PROPOSAL:

- **OCP Amendment** from Urban to Multiple Residential
- **OCP Text Amendment** to allow a higher density in the Multiple Residential designation.
- **Rezoning** from RF to CD
- **Development Permit**

to permit the development of a 6-storey residential apartment building with a child care centre.

Re: Proposed Residential Development @ 15316 88th Ave, Surrey BC; City of Surrey File No: 22-0307, Response to subsequent planning Comments & ADP Comments

LANDSCAPE PLAN

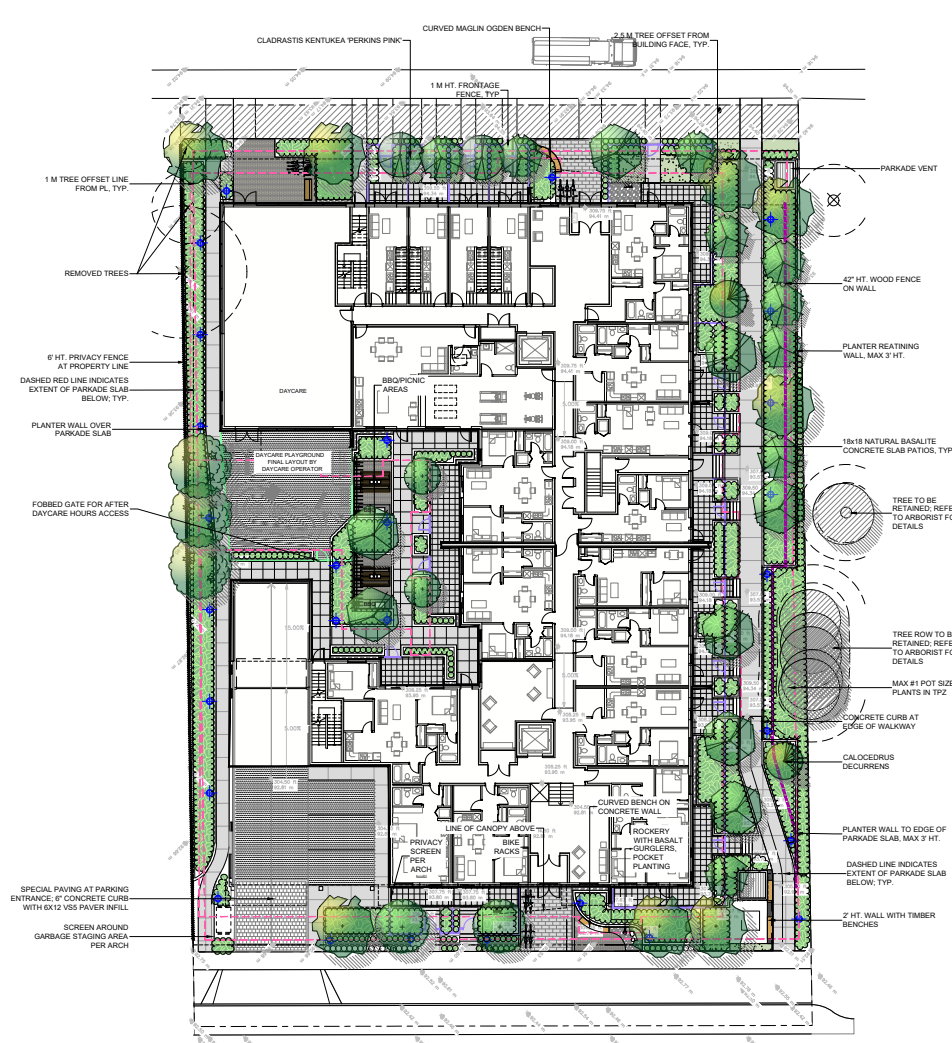
- Commend the team for proposing zero emissions building.
Thank you!
- Consider more hardscaping at the Daycare entry to accommodate bike parking and minimize lawn.
Lawn replaced with a mix of planting and increased paving.

- Review the retaining wall at the south-east corner and create a more sensitive interface, some walls are higher than 1.2m.
Fence has been set back from edge of wall to create a stepped interface. Planting is on both sides of fence, and a hedge is placed at the base of the wall to screen.

- Reconsider the use of grass in the front seating area and replace this with a more durable material.

Lawn replaced with a mix of planting and increased paving.

We've provided a 3' planted retaining wall with a 42" fence stepped back to create a soft, green transition between lots.
